At-site and regional frequency analysis of extreme ~~precipitation~~ rainfall in Belgium based on radar estimates

Authors response to Referee 1 comments

Authors response to Referee 2 comments

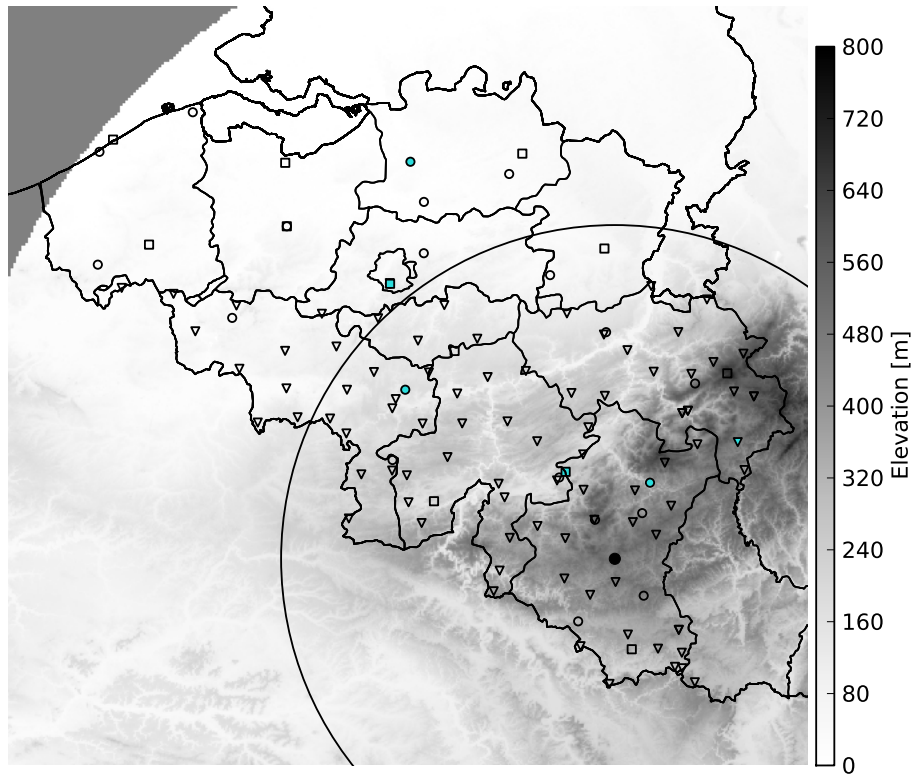
- Figure 1: what do the areas in the figure represent? Are they catchments? Are they used in the manuscript?
These are the provinces of Belgium. They are not used but are of interest for climatological purposes.

25 16. Figures 1, 6 and 7: a scale in km would help the interpretation of the figure, for those who are not familiar with Belgium

We added a 100 km circle to the maps.

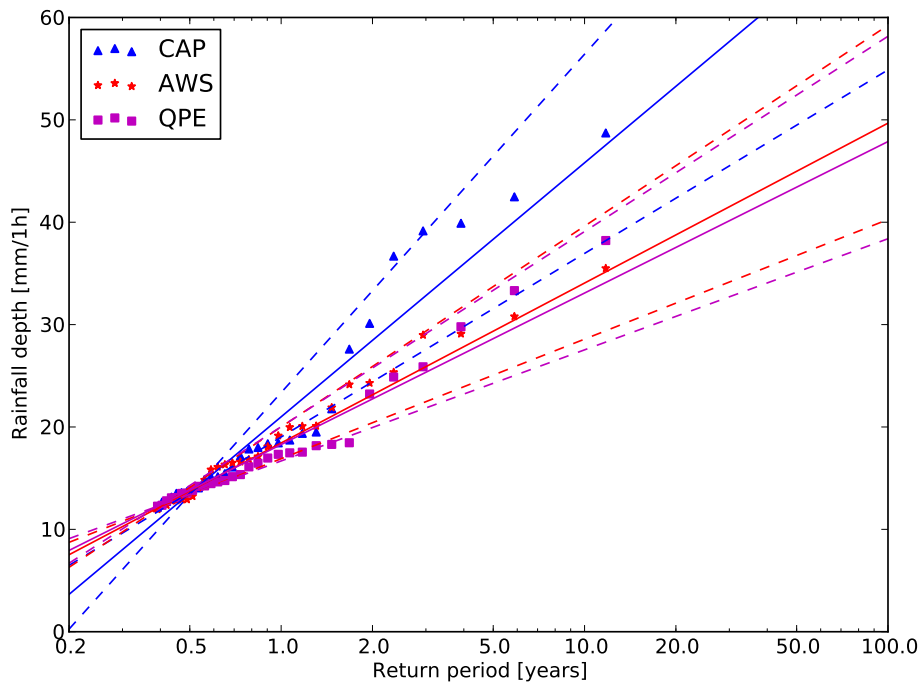
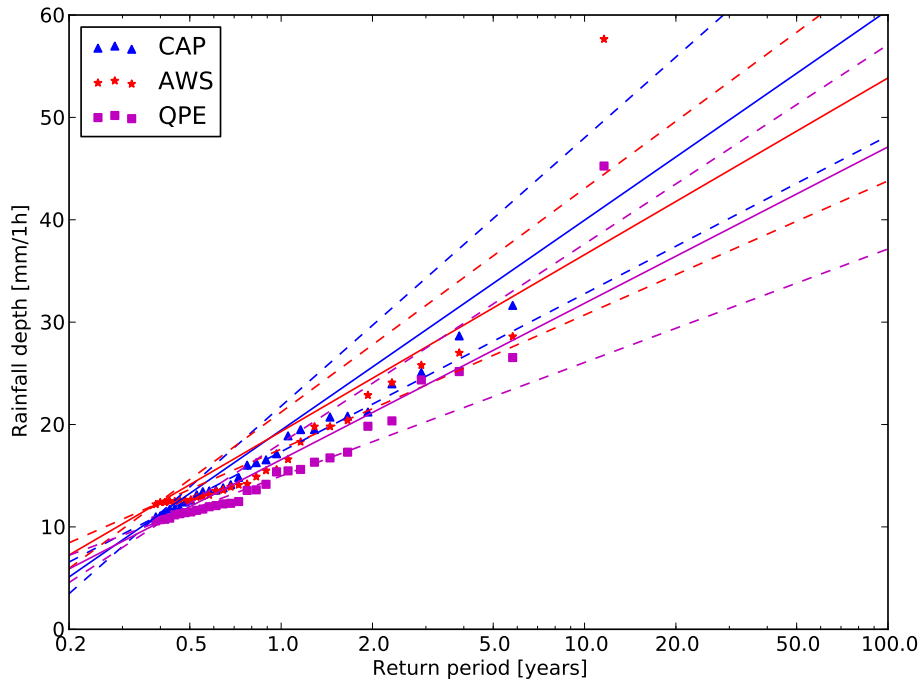
- page 6, lines 13-18: how is the return period used in the QQ-plots derived? Is it is done following Willems et al, 2007? This is a key aspect in the methods and in the shaping of the results and needs to be explained and discussed; [7, 12] how is figure 2 created? from Willems et al, 2007, I imagine that the figure shows on the x-axis the return period derived from the exponential distribution that maximizes the linearity of the relation – how is the maximization done?;

20 14. Figure 2. I suggest to rename “Extreme 1-hour precipitation quantiles” to “1-hour return levels”, to be consistent with theory and common nomenclature in the field.

It is unclear what the referee means by the "usage" of return periods in QQ-plots. The text related to Figure 2 has been improved. Please see page 10, line 18. The optimisation procedure is explained on page 9, line 13.

The figures legends have been modified.

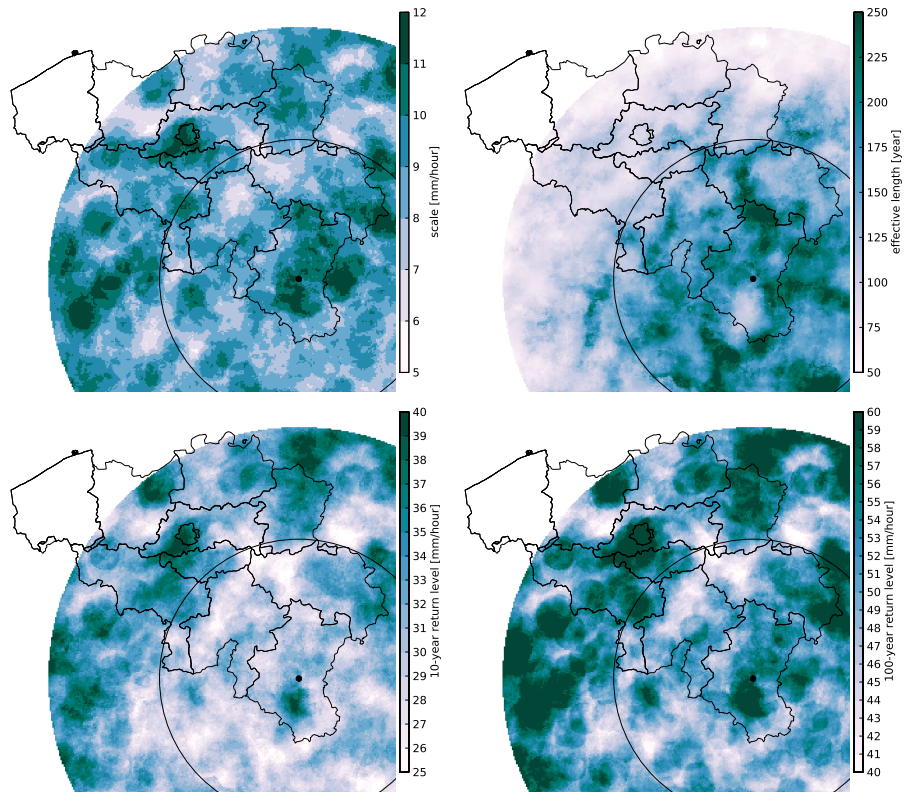
– Figure 6, 7: Can the circular patterns be caused by the regionalization method (in case problematic pixels are still there, one will choose them when selecting the max value within the circular area – see also [10, 20-21])? Can this represent a weakness of this method?

There is indeed an impact of the circle from the RFA but it is relatively limited in most of the study area. Since this is mainly
due to radar artifacts we don't consider it as a drawback of the proposed RFA method. The discussion has been improved
as follows : "Circular patterns appear on the maps due to the influence of the pixels located at their centers. The high values
15 are caused by pixels contaminated by non-meteorological echoes (e.g. at the German border) and hail. A stronger filter for
non-meteorological echoes is not used because it could remove actual precipitation information. The circular effect might be
reduced by using a larger radius or a higher threshold rank but this is computationally expensive." The RFA has been limited
to 1 hour extremes in this paper since it has the best potential for radar data. Extending the approach to other durations is
interesting for future research.
